# ***PM8841 Power Management IC***

## ***Device Revision Guide***

***80-NA554-4 Rev. H***

***June 20, 2013***

Figure 1 PM8841 device marking (top view – not to scale)

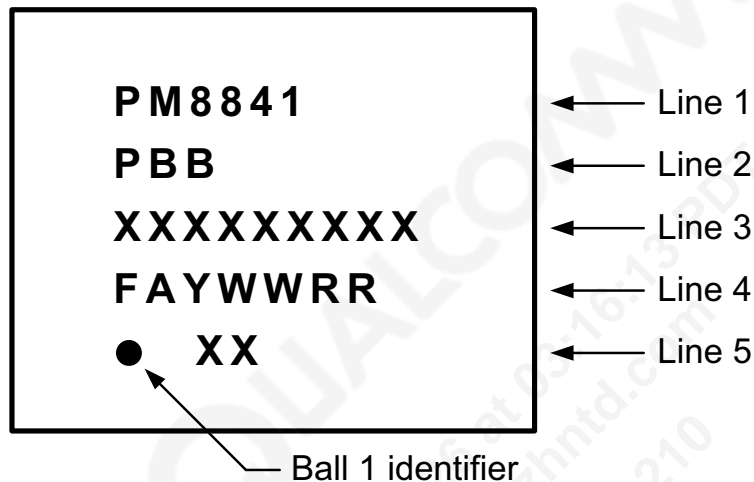
Revision	Date	Description
A	September 2012	Initial release
B	October 2012	Updated the part marking figure and description in Section 2.1 Device marking Added the feature code (BB) definition to Table 3 PM8841 device identification details Added the following issues: <ul style="list-style-type: none"> <li>■ Issue 3 Certain PMIC modules not trimmed correctly</li> <li>■ Issue 4 Internal pull-down on PON_1 pin of PM8841 enabled by default</li> </ul>
C	December 2012	Updated Issue 1 PMIC off current (IBAT_3) not meeting specification Added Issue 5 PMIC does not meet absolute maximum VPH_PWR specification and Issue 6 Multiphase FT SMPS show abnormal current balancing during phase transition
D	March 2013	Added new sample type and corresponding identification details to Table 3 Updated Table 4 to include listing of new sample type and new issues Added the following issues: <ul style="list-style-type: none"> <li>■ Issue 7 FT SMPS PFM efficiency does not meet specifications</li> <li>■ Issue 8 FT SMPS can exhibit multiple switching pulses within a single switching period</li> </ul>
